**AFRICAN INFRASTRUCTURE INVESTMENT MANAGERS**

## IRP UPDATE, 2016

CONSULTATION 13<sup>TH</sup> DEC 2016

### IRP 2010

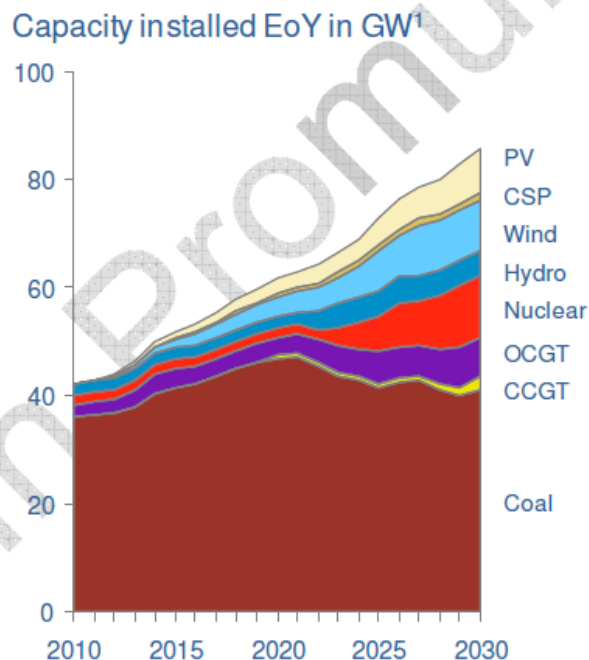
IRP 2016 – illegible. TWh data not readily accessible in supporting documentation. Total cumulative capacity incorporating retirement unclear

Provide more in-depth supporting information no later than end January 2017, including TWh mix and *total cumulative* MW mix
